**BWEA Reponse: Scottish Grid Code Review Panel Consultation SA/2004 -
Consultation on Technical Requirements for Windfarms**

This document is the BWEA response to Scottish Grid Code Review Panel Consultation SA/2004 and has been compiled with support from Econnect who, as you will be aware, have worked with BWEA on previous Grid Code consultations.

Figure 1: Dynamic performance of a 2MW FSIG wind turbine to a voltage disturbance

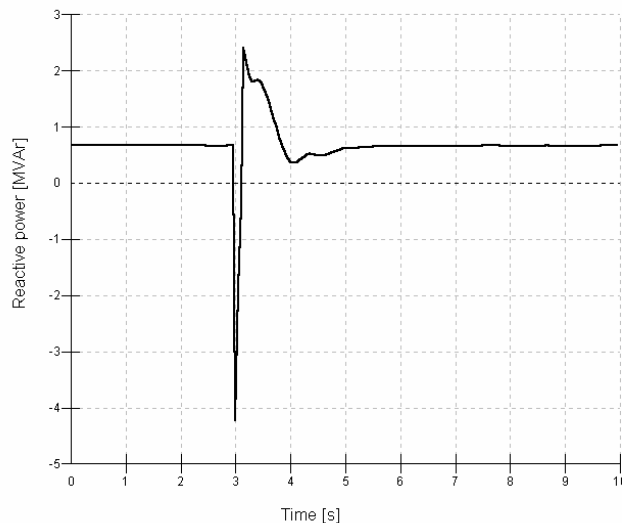
The statement in Changes since previous proposals that “Generators should not draw MVar from the network during faults” should also be removed as it is not consistent with the Connection Conditions, and is extremely difficult to achieve in practice, as Figure 1 showing the reactive power response to a fault of a fixed speed induction wind generator illustrates. The response of a doubly fed induction generator is similar though less extreme, however such a fault would still result in MVar being imported from the network.

Figure 2: Possible voltage duration profile for which power park module should remain connected under Grid Code proposals.

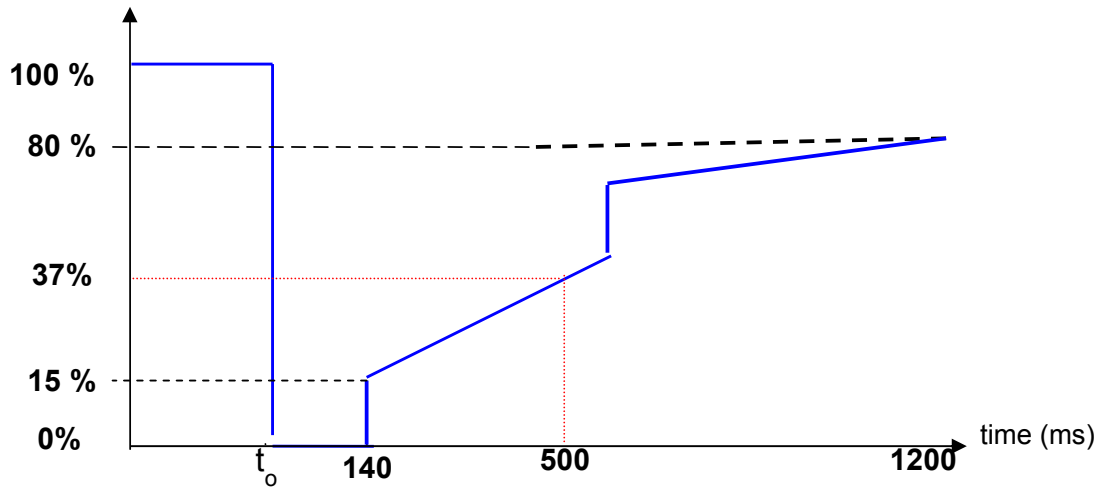
There is also no mention of what the requirement would be in the scenario described in Figure 2 below where the supergrid voltage has not recovered to 90% within 500ms of the fault occurring.

The characteristic in Figure 2 is within the voltage duration profile specified for which a power park module should remain connected, however considering the situation below at 500ms after the fault, surely it would be better for a power park module to disconnect than continue to draw MVar from the system and further depress system voltage, or alternatively, avoid having to provide significant voltage compensation equipment to remain connected under such a scenario.
